ELECTRICAL SAFETY FOLLOW UP INSPECTION REPORT (11TH)

Factory Name	APS Apparels Ltd.					Note:
Address	Holding No.106, Ward- 5, Baitur Rahmat, Mosque Road, E-Faidabad, Atipara, Dokhin Khan					
FACTORY ID	9438	ELECTRICAL SAFETY INSPECTION DATES				Other Factory: ----- ----- ----- ----- ----- ----- -----
Initial Inspection Date	25/03/2014	Date of 5 th Follow Up	06/09/2016	Date of 11 th Follow Up	30/01/2019	
Report Received Date		Date of 6 th Follow Up	28/11/2016	Date of 12 th Follow Up		
Date of 1 st Follow Up	05/04/2015	Date of 7 th Follow Up	09/02/2017	Date of 13 th Follow Up		
Date of 2 nd Follow Up	28/12/2015	Date of 8 th Follow Up	03/05/2017	Date of 14 th Follow Up		
Date of 3 rd Follow Up	22/03/2016	Date of 9 th Follow Up	27/08/2017	Date of 15 th Follow Up		
Date of 4 th Follow Up	28/06/2016	Date of 10 th Follow Up	02/04/2018	Date of 16 th Follow Up		
Inspected by		Mst Rebeka Sultana

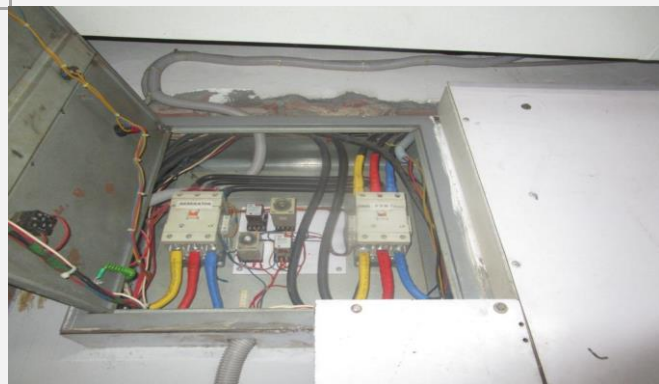
47	New Finding: Cables terminated without cable lugs	Terminate all the power/earth/neutral cable with proper sized cable lug.	1 month	On 22/03/2016: Corrected.	'31/01/2016	Corrected. We have completed the work as suggested.	Corrected
